MARK	DATE	DESCRIPTIONS	BY	CK	CCO
1	8/6/07	Electrical modifications.	MP EL	RR	42
REVISIONS

CONTRACT CHANGE ORDER NO. 42
SHEET ____ OF ____

DETAILS
SAS SUPERSTRUCTURE GIRDER EASTBOUND 480 V LIGHT PIPE WIRING DIAGRAM
NO SCALE

E-189

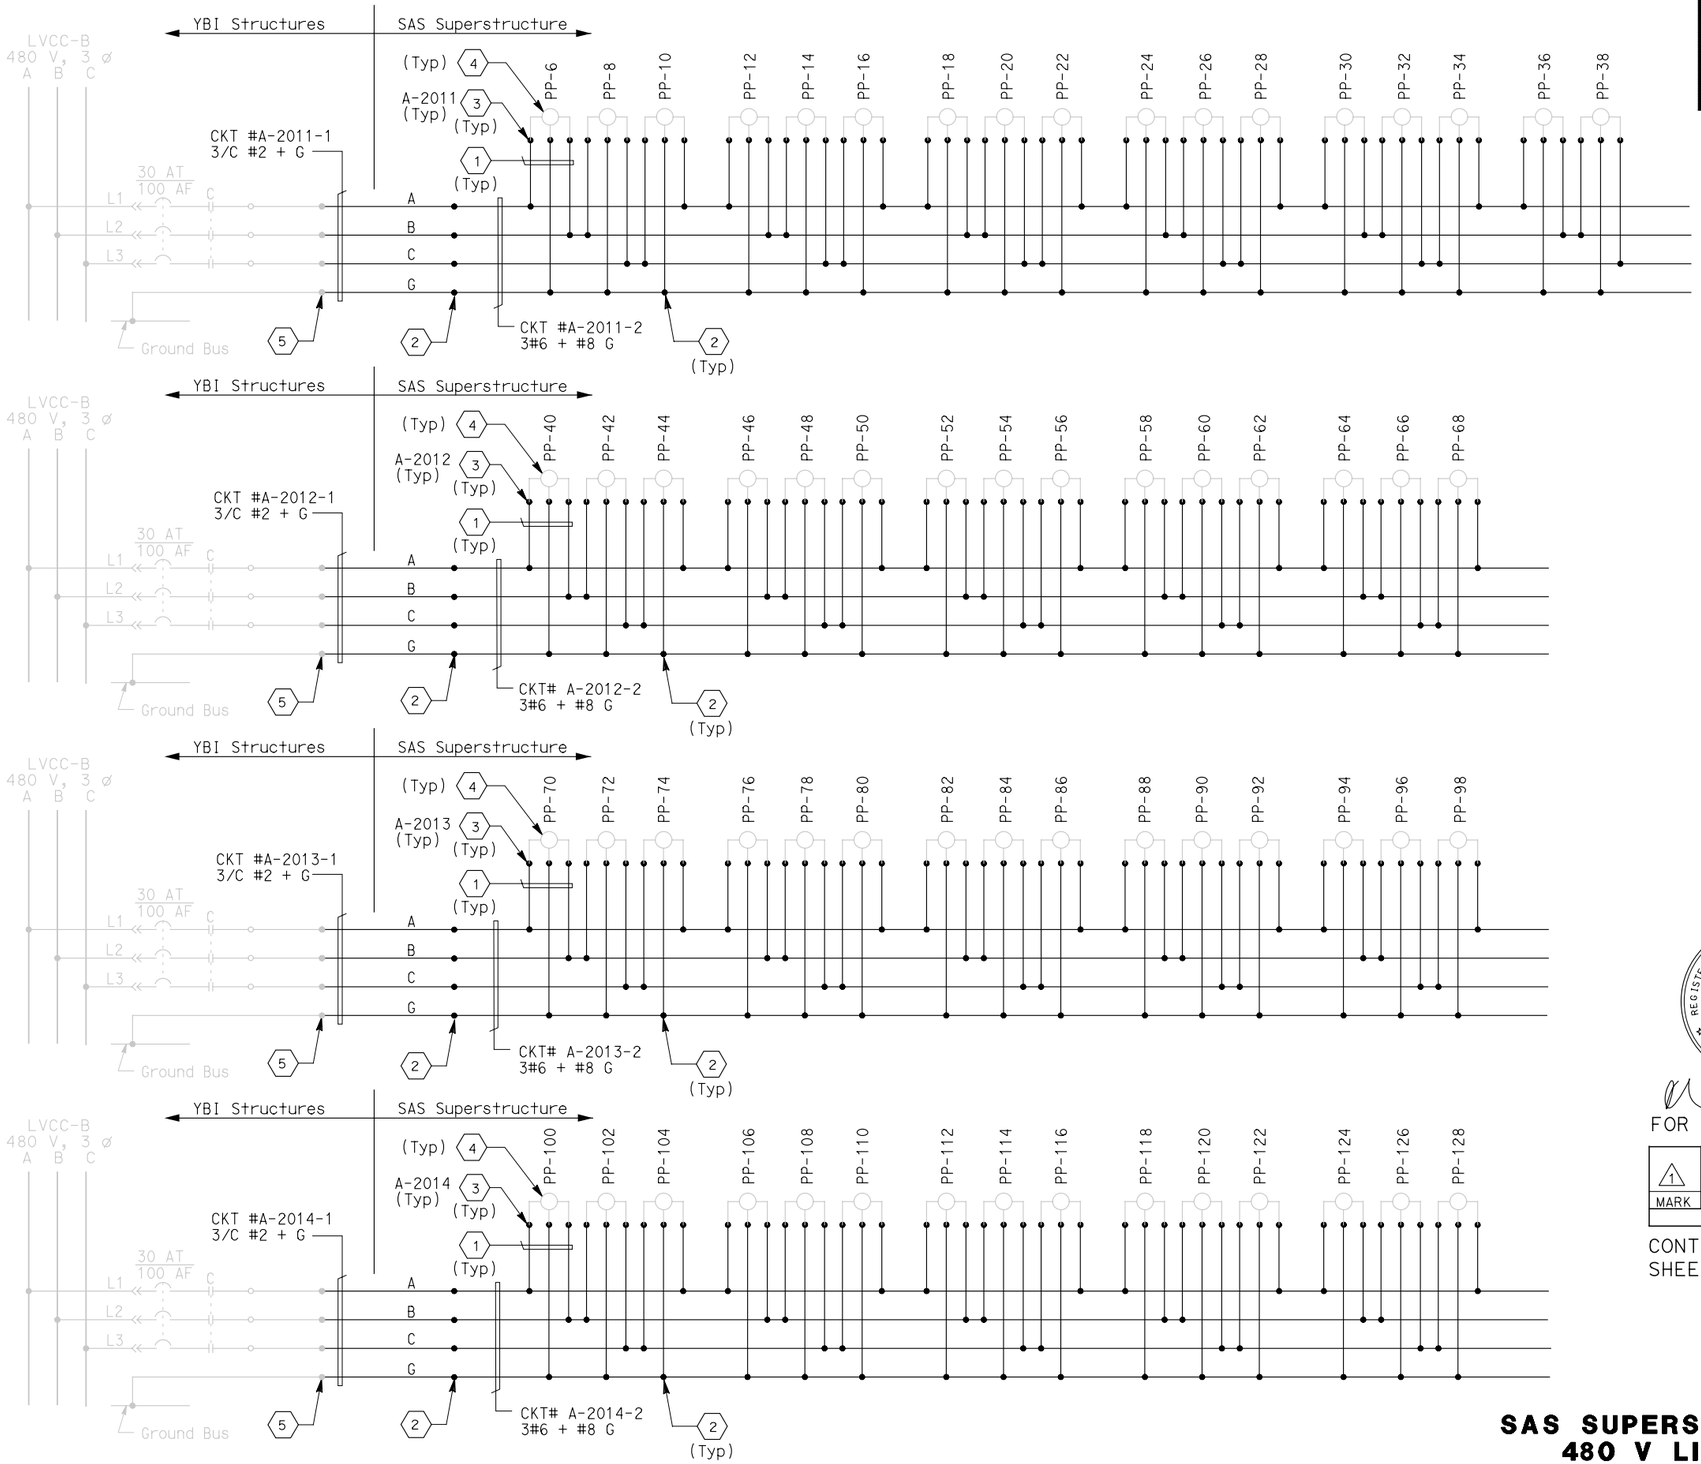
1. 2#10 + #10 G single conductors.
2. Conductors spliced in pull box PB-2A (1) located inside the girder. (Inside)
3. Future light pipe connections. Coil and tape end of conductors ~~in the first~~ pull box ~~PB-2A~~ located ~~inside girder~~. PB-1E (1) inside barrier
4. Future light pipe not included in this contract.
5. The Contractor shall extend and coil 5.0 meters of cable in manhole #25. All cables shall be tagged with circuit numbers as shown.
